**DOCUMENT 00 90 00  
ADDENDUM**

**ADDENDUM NO. [3]                      Date: February 20, 2019**

**RE:                      EAU CLAIRE AREA SCHOOL DISTRICT  
                              SECURE ENTRANCES  
                              LOCUST LANE  
                              MEADOWVIEW ELEMENTARY  
                              MEMORIAL HIGH SCHOOL  
                              SOUTH MIDDLE SCHOOL**

**EAU CLAIRE, WISCONSIN 54701  
HSR PROJECT NO. 18044**

**5 DETAIL AT AHU C.W. COOLING COIL 3-WAY CONTROL**  
N.T.S.

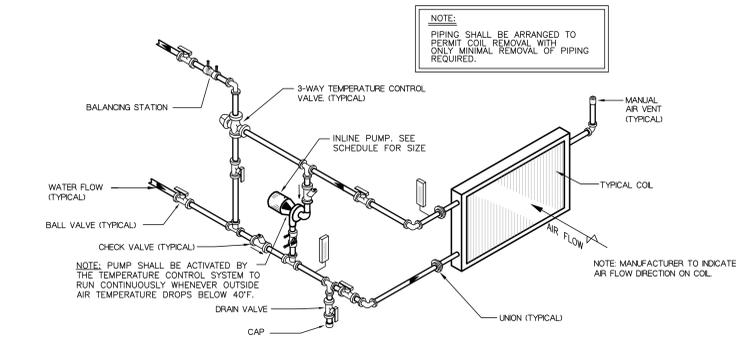
i. 3.05 AIR HANDLING UNIT (AHU-1 & 2), G, 1: Change reference to DX cooling coil to “chilled water cooling coil.”
